Re: Response to the request for clarification

Reference is made to the tender for Supply, Installation and Commissioning of Diesel generator sets and Digital voltage regulators at Kigali International Airport, tender reference NO: 002/NCB/G/2022-2023

# CENTRALE ELECTRIQUE SD 002

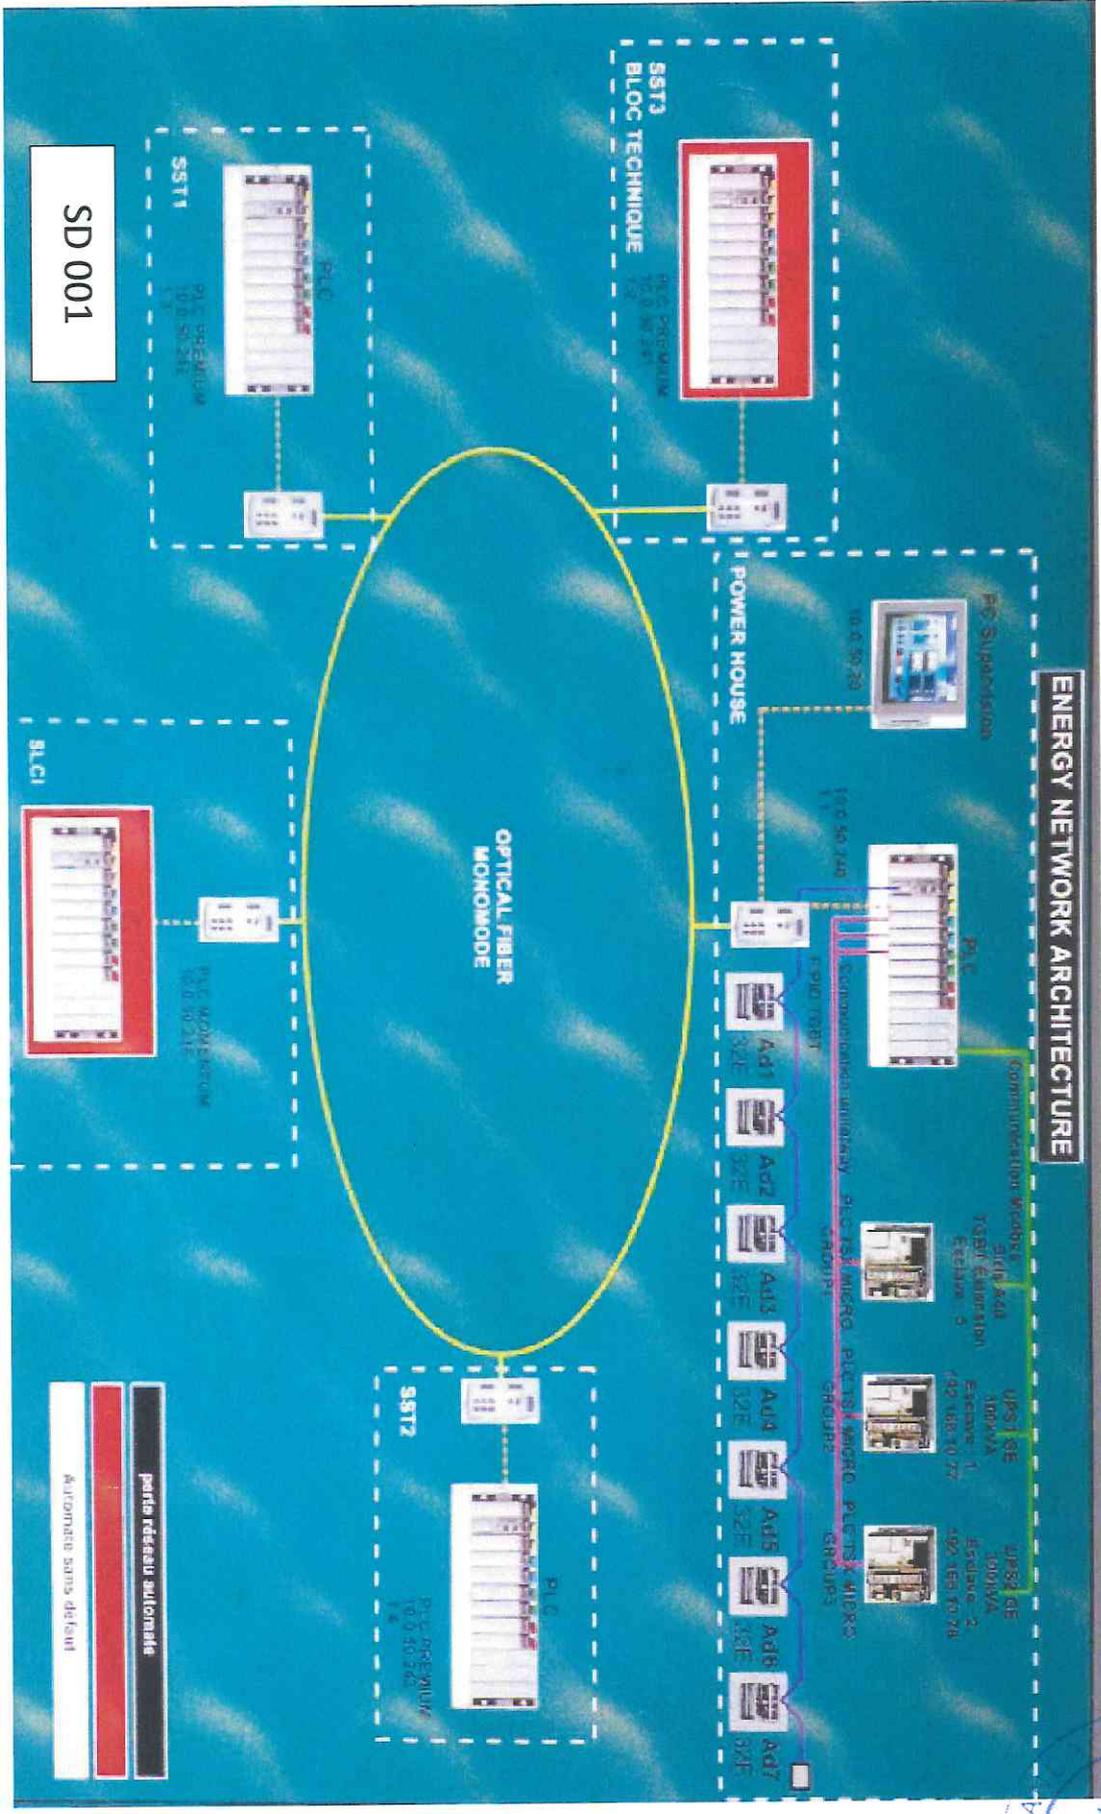
4	Single Line Diagram (SLD) and drawing of the LV switchgear where AVR going to be connected.	Refer to the schematic drawing SD002 here attached the DVR connectivity. It will be connected to the common busbar of CD1 and CD2.
5	SLD and drawing of the LV switchgear where faulty generator is currently connected.	It is a replacement of the existing and shall be connected where the existing G1 was connected. Refer to the drawing SD002 here attached.
6	Single Line Diagram (SLDs) and drawings of existing system where this Genset going to be connected	Hope here you are talking about the new generator for Technical Block (150kVA). This is an automatic generator, which will be installed together with the AMF and then from the AMF to the main LV Board for the building. Refer to the SD003 (Technical Block) here attached.
7	Communication architecture showing the PLCs and SCADA of this section.	Find it in the attached SD 001.
